## PLAN SNAPSHOT REPORT DHOWVR-2025-00018 FOR CITY OF ALBUQUERQUE

RE: Application for Preliminary Plat for  
the subdivision of  
3017 11<sup>th</sup> Street NW

Project: 3017 11<sup>th</sup> St. NW  
Subdivide Lot 8A  
McDonald Acres Subdivision Agenda Item No: 8

SU - 101

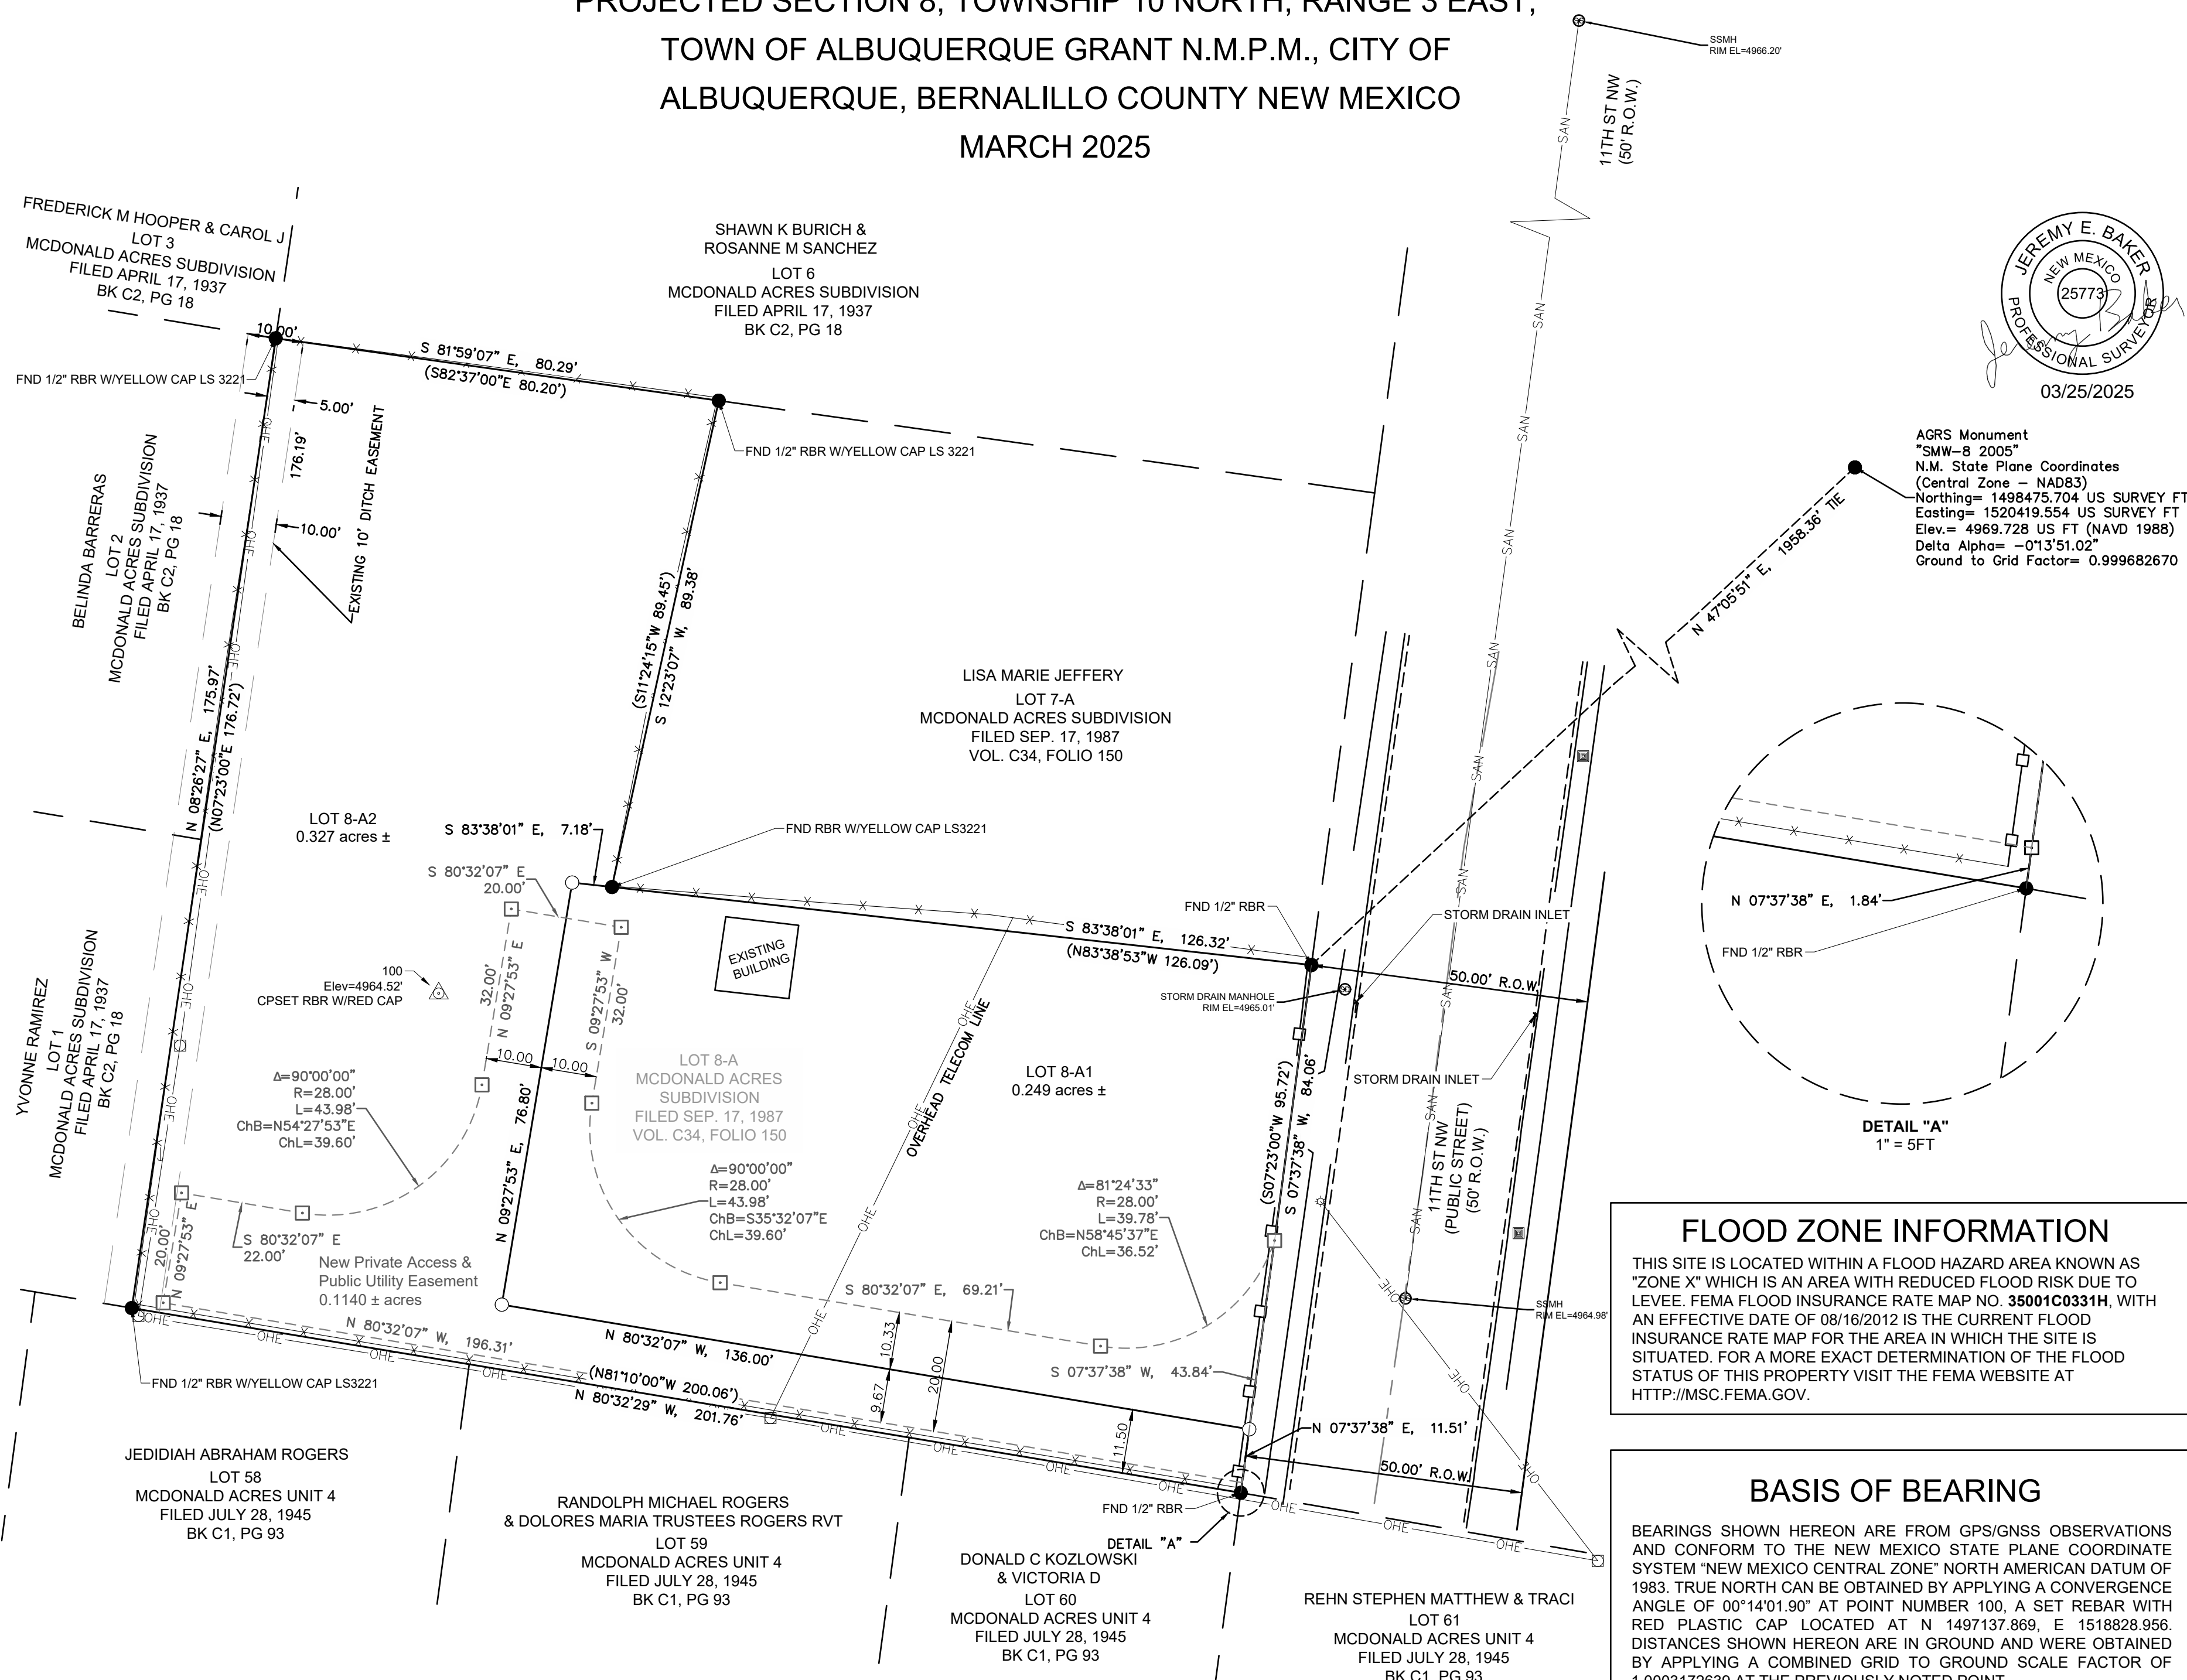
1. 11<sup>th</sup> is a local street and requires 5' sidewalk with a 4' to 6' landscape buffer. Please provide a cross section at the street dimensioning ROW, Walls or fences, sidewalk width, buffers, curb and gutter.
2. The existing driveway to this property appears as it will need to be relocated based on your proposed plat and the aerial photos.

- Planning defers to Transportation regarding the IDO/DPM requirements for the private road/driveway as depicted on the Sketch Plat, including turn-around requirements.

① Drainage Plan  
1" = 10'-0"

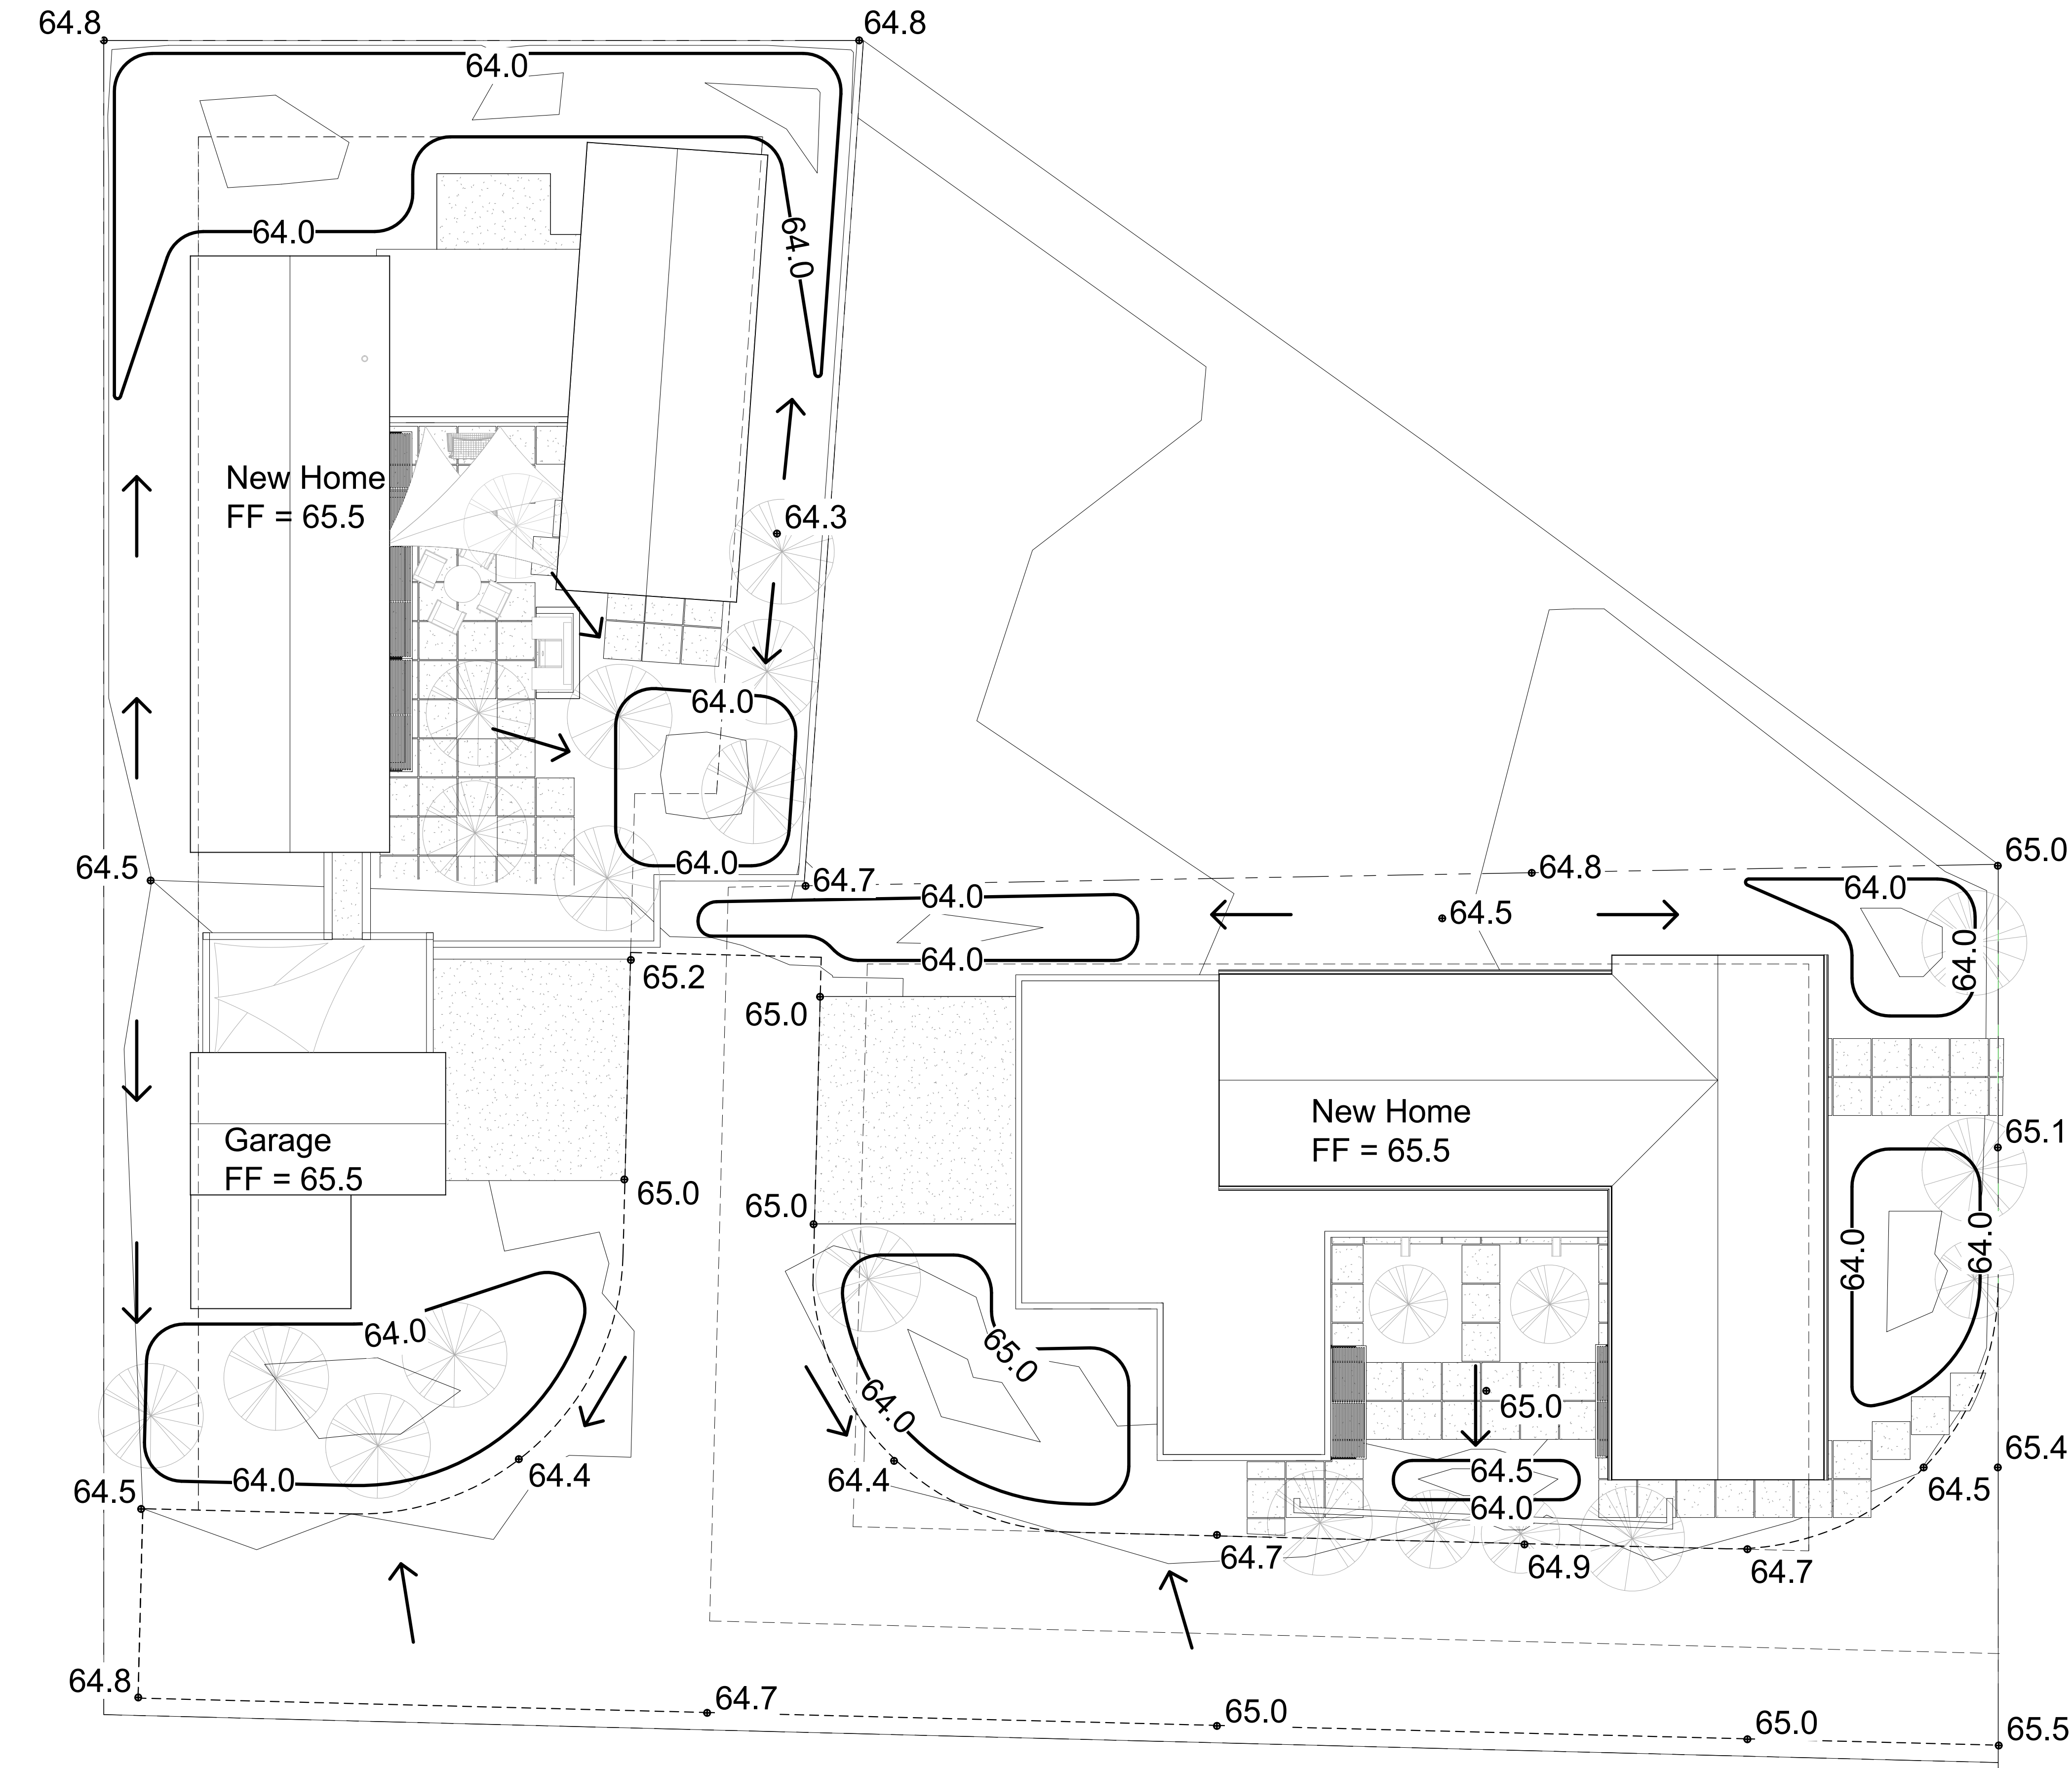
- Hydrology needs to approve a conceptual Grading & Drainage Plan prior to Plat approval.
